## CITY OF GLENDALE, CA

### DESIGN REVIEW STAFF REPORT – MULTI-FAMILY / MIXED USE

**422 West Elk Avenue**

**PADR-003408-2024**

# A3

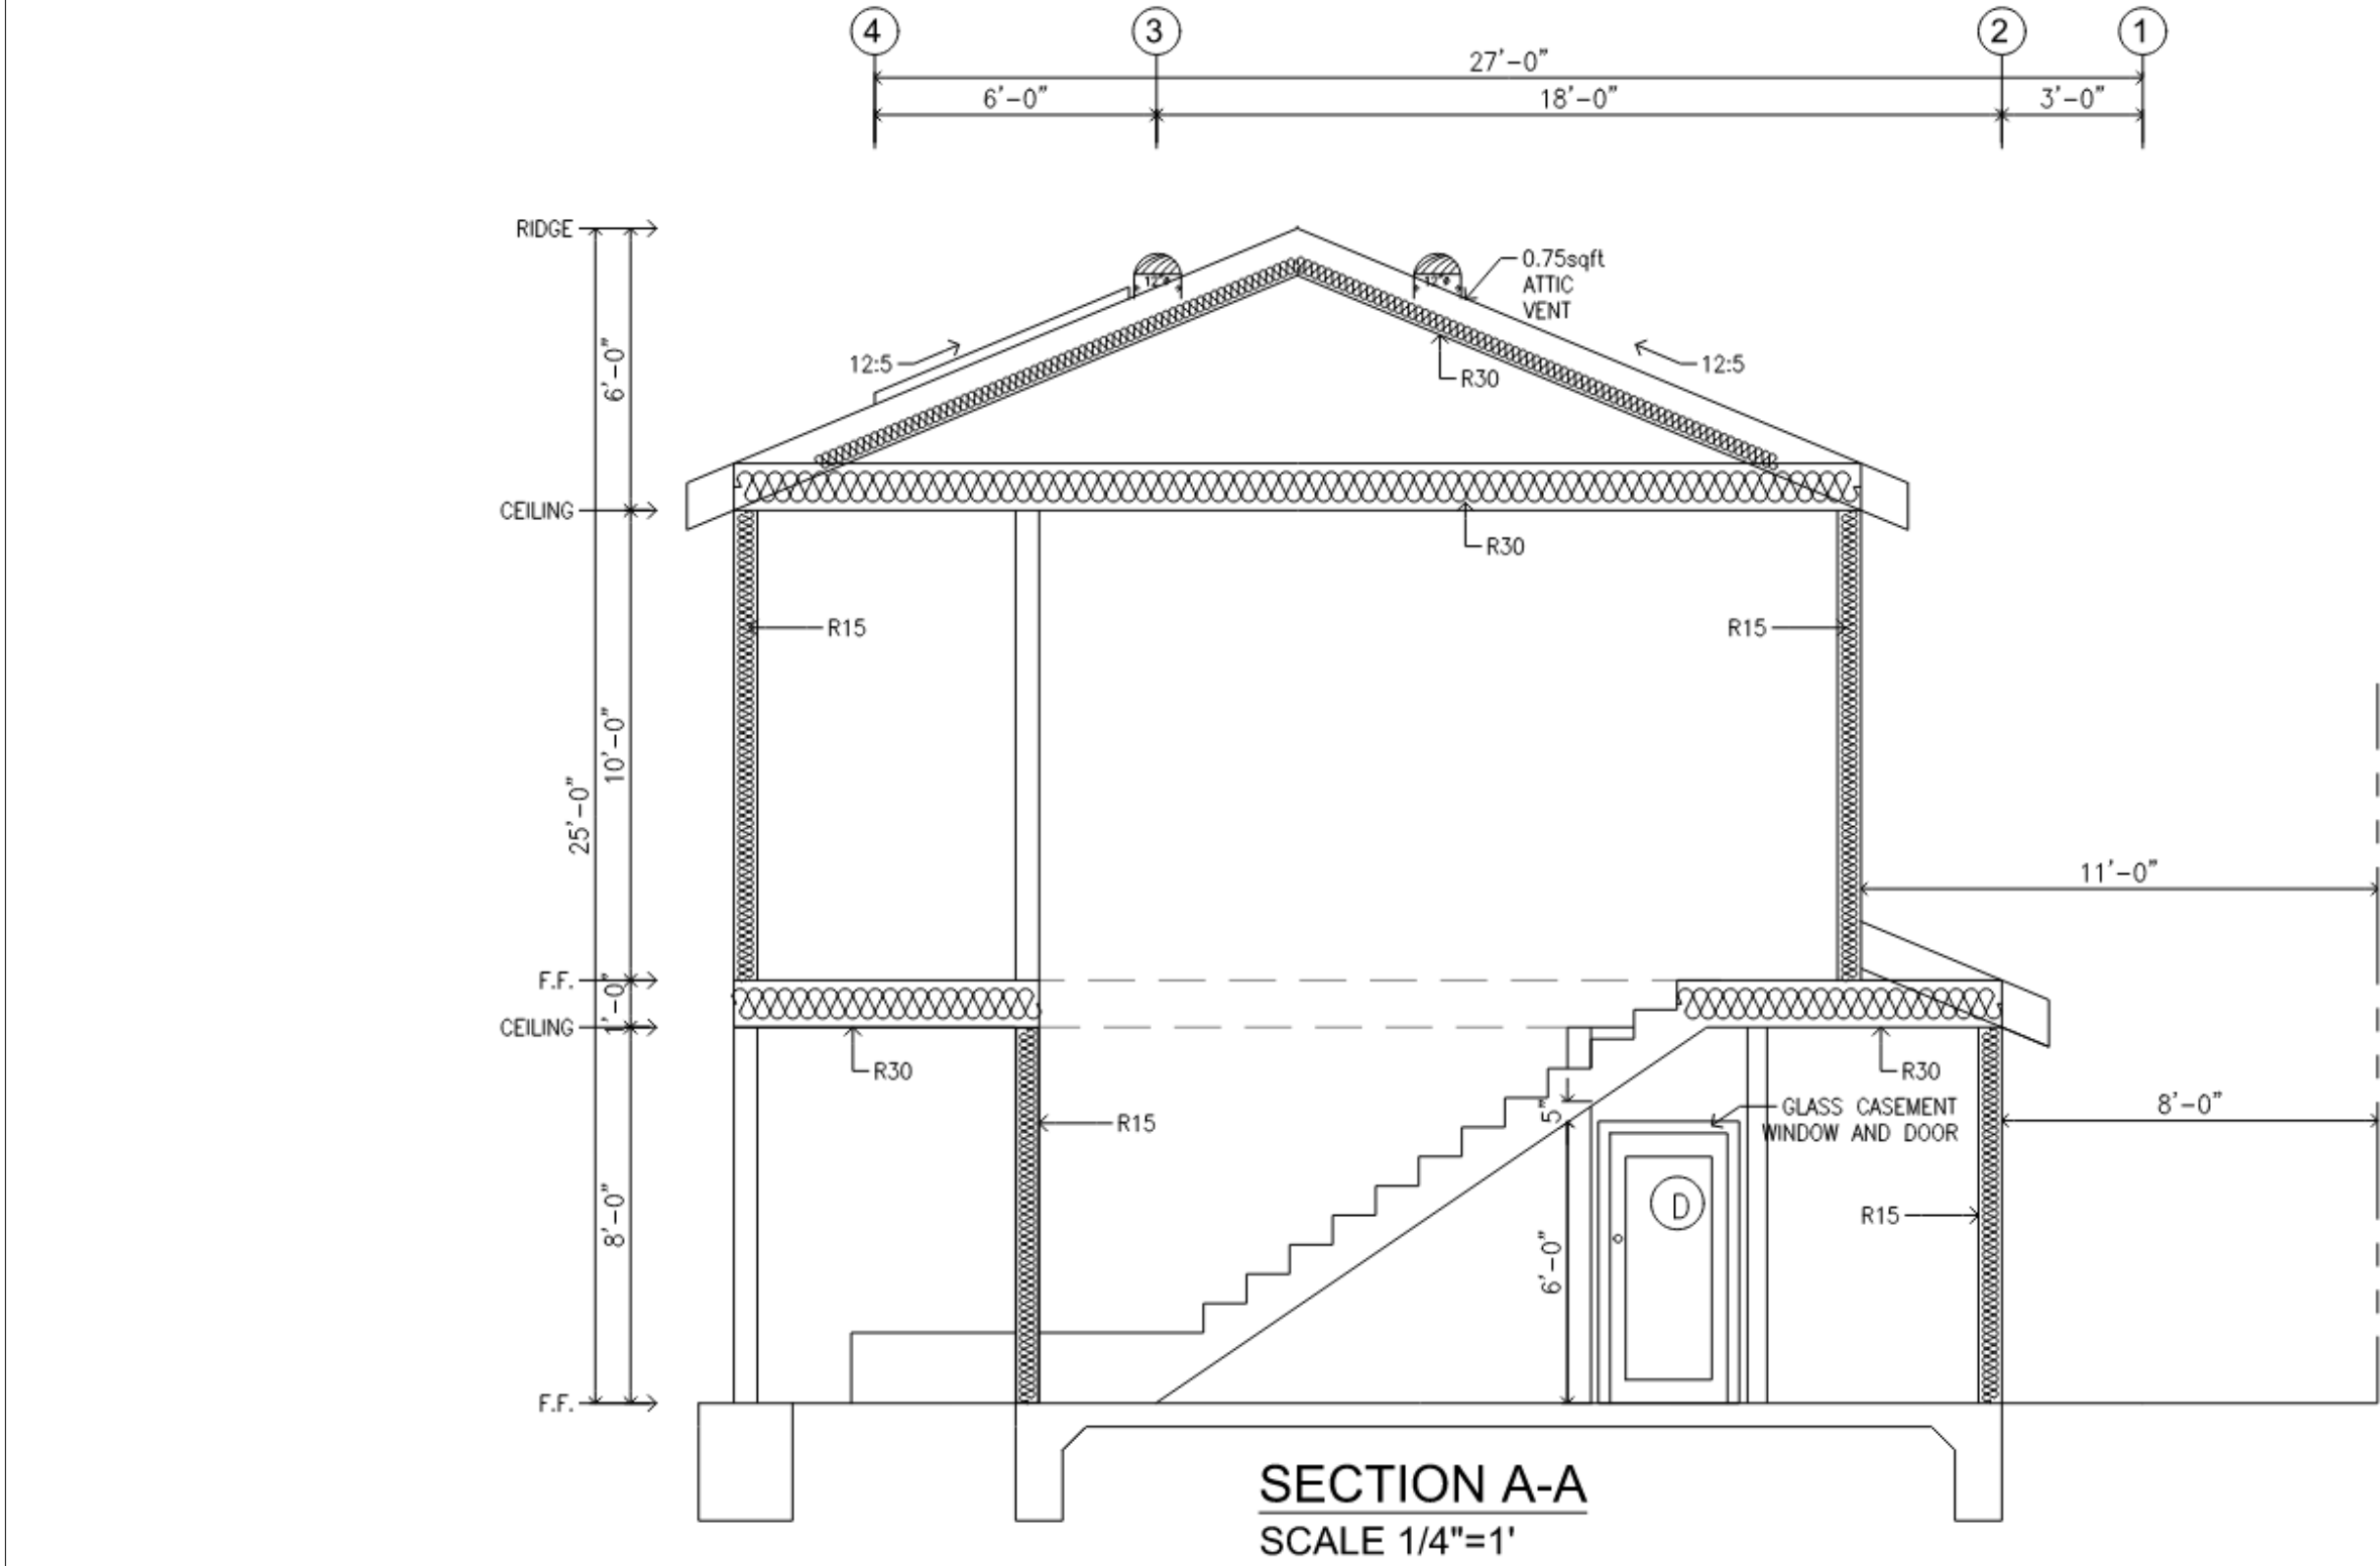
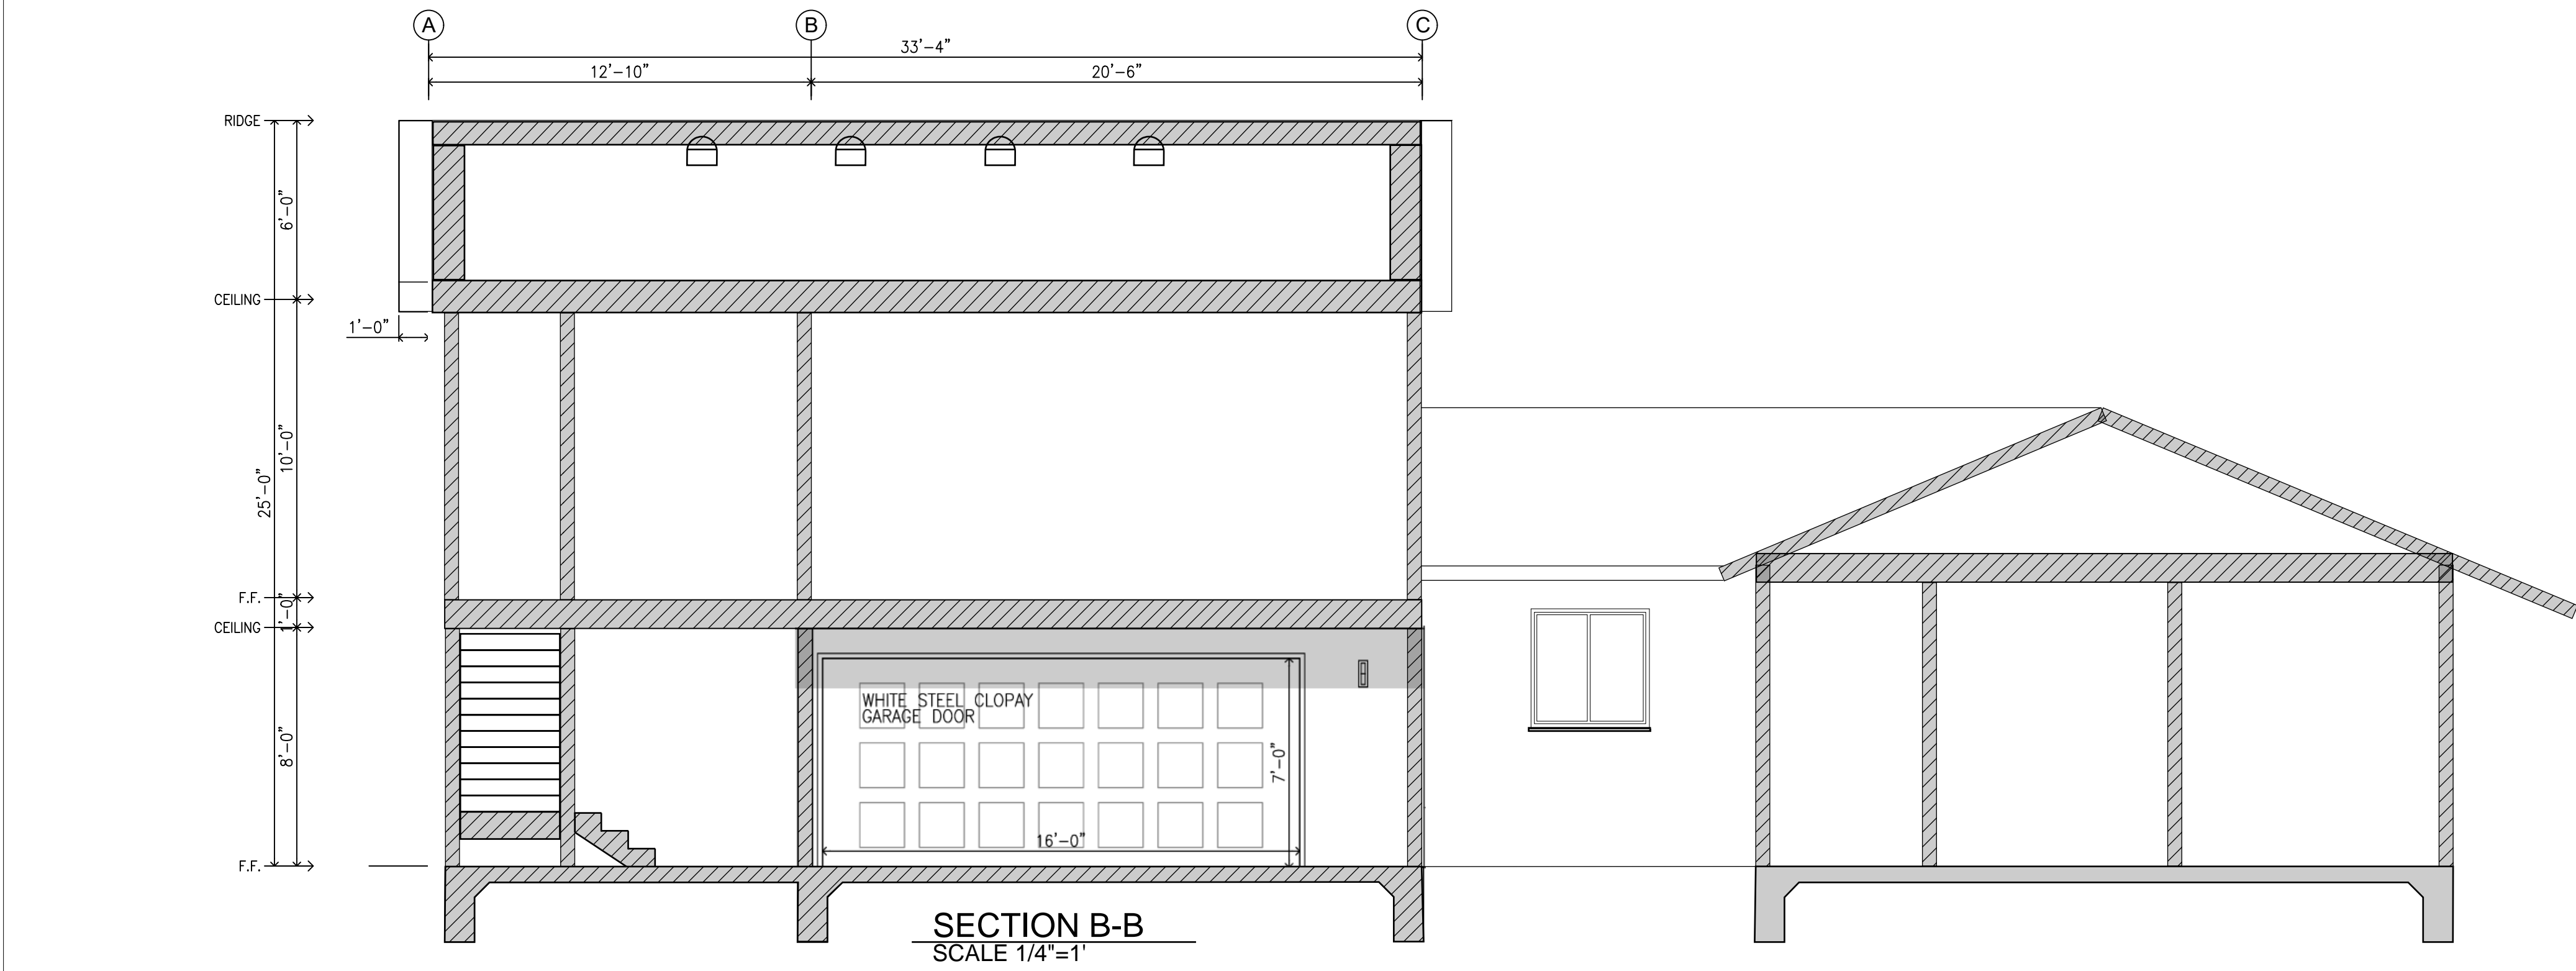
While the elevation shows light fixtures, the product information and specifications are not included. A condition is proposed requiring submittal of product sample image and specifications.

1. Provide a sample image of the new sconces with specifications.
2. Submit complete landscape plan(s) pursuant to GMC 30.31.020.
3. Revise plans to show the downspouts and gutters in appropriate locations.
